Historic Review
Staff Report for a Solar Installation on a Designated Historic Site
in the McLoughlin Conservation District
May 17, 2024

FILE NO.: GLUA-24-00006 and HR 24-00005: Historic Review

REQUEST: Historic Review for solar panel installation on street-facing roof planes on the James and Sarah Roake House, a designated structure in the McLoughlin Conservation District.

Proposed roof and mechanical equipment plan

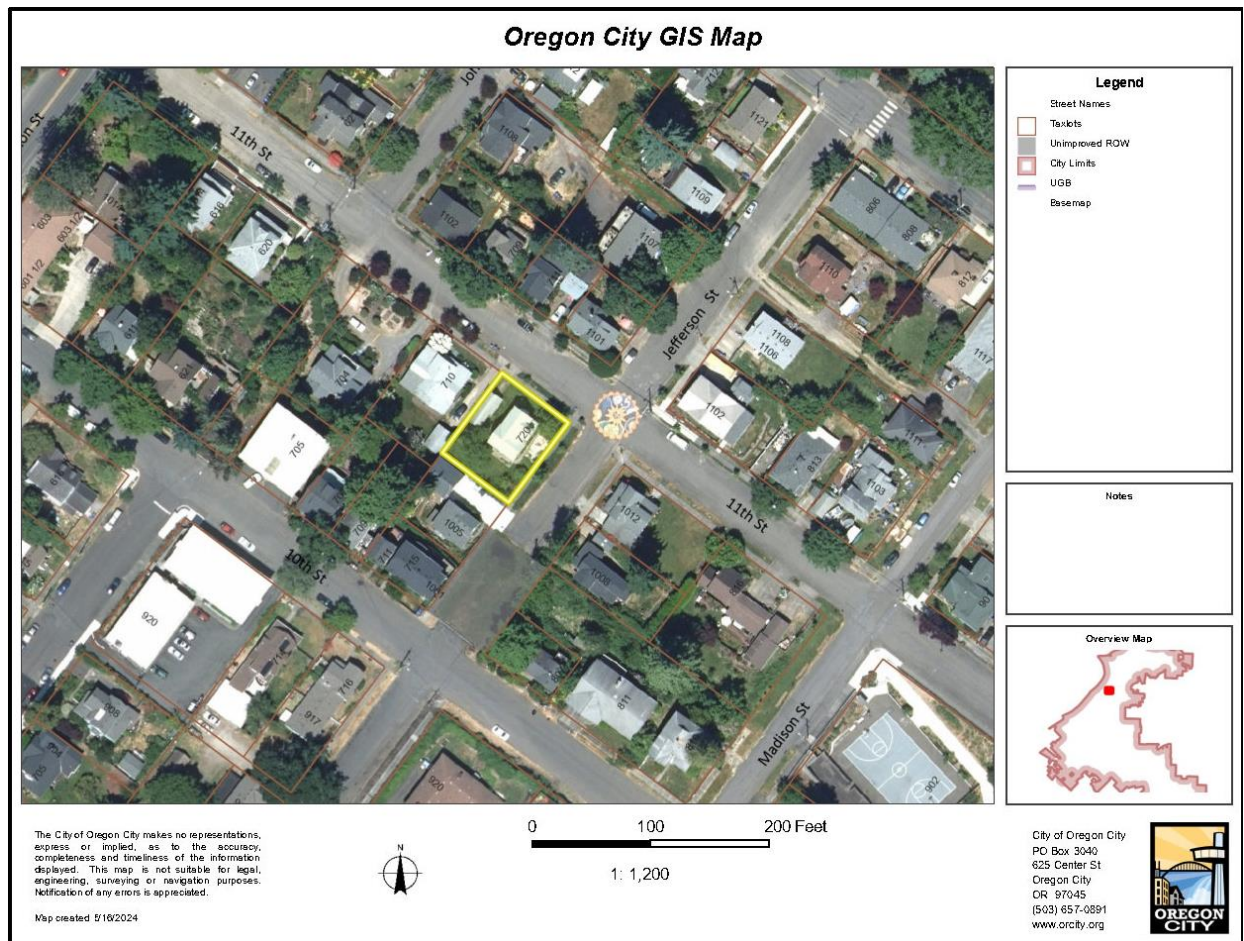
The proposed solar array configuration involves the placement of 9 panels covering 12.4% of the structure's roof surface. Seven of the nine panels are proposed to be located on the southwestern roof plane – the roof plane with the highest solar irradiance – two floors above grade. Two panels are proposed along the northwest-facing roof gable, a roof plane with significantly lower solar irradiance.

Historic Review Board Policy 12 for solar panel installations recommends that solar panels be placed on “secondary roof planes.” In the case of the James and Sarah Roake House, Staff is seeking direction from the Historic Review Board as to whether the proposed solar panel configuration on the northwest-facing 2nd story gable visible from 11th St meets that standard, or recommend an alternative configuration that might meet the standard in this case.

The panels proposed on this home are proposed on the rear side and front-facing roof slopes and placed such that they will be visible when viewing the primary façade of the house from the right of way. Thus, staff was unable to make a finding that the two panels located on the northwest-facing gable along the primary 11th Street façade were on a secondary façade. Therefore, HRB review is required for this proposal.

Finding: Complies with Condition: The James and Sarah Roake House is a Queen Anne-style structure with a moderately pitched gable roof and cross gable located 2 stories above street grade. The roof on the structure is a dark composition shingle. A total of 9 panels are proposed, with 2 on the street-facing roof planes. All panels would be visible from the street frontage.

If the Board finds that these panels will impact this historic integrity of the home as proposed, the circumstance may be mitigated by limiting the number of panels on the upper roof plane, or moving the panels to the next most viable and irradiant roof planes.

1. The applicant shall submit documentation showing that the panels will be no more than 5” above the roof surface.
2. The applicant shall submit documentation confirming that the number and location of the 11th Street-facing solar panels is either necessary for the viability of the project, or an alternative solar panel configuration on other roof surfaces that meet Historic Review Board standards.
3. The panel frames shall be black, no unfinished/shiny metal frames or visible parts are permitted.

4. Ground- or wall-mounted equipment shall not obscure any architectural features and shall not be installed in a manner that destroys historic millwork or other historic materials. The applicant shall submit a sketch or mock-up of the equipment placement to staff to demonstrate compliance with this condition.
5. The applicant shall ensure that the ground-mounted equipment is blocked from pedestrian view by the use of fencing or landscaping.
